Access Compliance Report

Public Rights-of-Way

Intersection ID: 50342	Main Street: HERMISTON_ST	Cross Street: STIRLINGSHIRE_CT	Location: SE
ADA ID: 498A74559680	Ramp Type: Perp	Initial Pass/Fail: Fail	Overall Compliance: No
Severity Score: 22.5			
Codes/Mitigation Info/Possible Solution		Field Measurements/Component Compliance

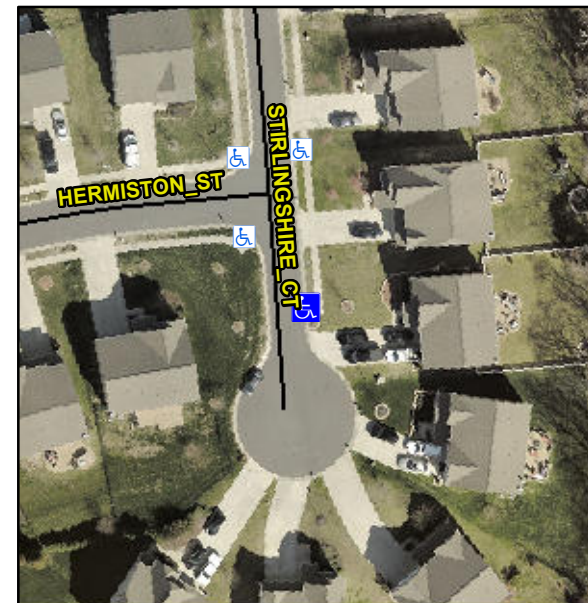
R304.5.1, R304.2.2, R304.5.3

Compliance	Description	Data	Compliance	Description	Data
N/A	Ramp Length (in)	48.0	No	Ramp Slope (%)	10.0
No	Ramp Width (in)	47.5	No	Ramp XSlope (%)	2.1
N/A	Flare Type LT	N/A	N/A	Flare Type RT	N/A
N/A	Flare Slope LT (%)	N/A	N/A	Flare Slope RT (%)	N/A
N/A	Flare Traversable LT?	N/A	N/A	Flare Traversable RT?	N/A
N/A	Landing Length (in)	N/A	N/A	DWS Provided?	N/A
N/A	Landing Width (in)	N/A	N/A	DWS Contrast?	N/A
N/A	Landing Slope (%)	N/A	N/A	DWS Length (in)	N/A
N/A	Landing X Slope (%)	N/A	N/A	DWS Full Width?	N/A
N/A	Landing Curb? (Y/N)	N/A	N/A	DWS Offset (in)	N/A
N/A	Shared Landing?	N/A			
N/A	Gutter Ponding?	N/A	N/A	Gutter Slope (%)	N/A
N/A	Gutter Lip Ht (in)	N/A	N/A	Gutter X Slope (%)	N/A
N/A	Painted X Walk1?	No	N/A	Painted X Walk2?	N/A
	X Walk 1 Direction	To W		X Walk 2 Direction	N/A
N/A	X Walk 1 Width (in)	N/A	N/A	X Walk 2 Width (in)	N/A
	X Walk 1 Slope (%)	2.5		X Walk 2 Slope (%)	N/A
	X Walk 1 X Slope (%)	1.0		X Walk 2 X Slope (%)	N/A

Remove & Replace Entire Ramp.
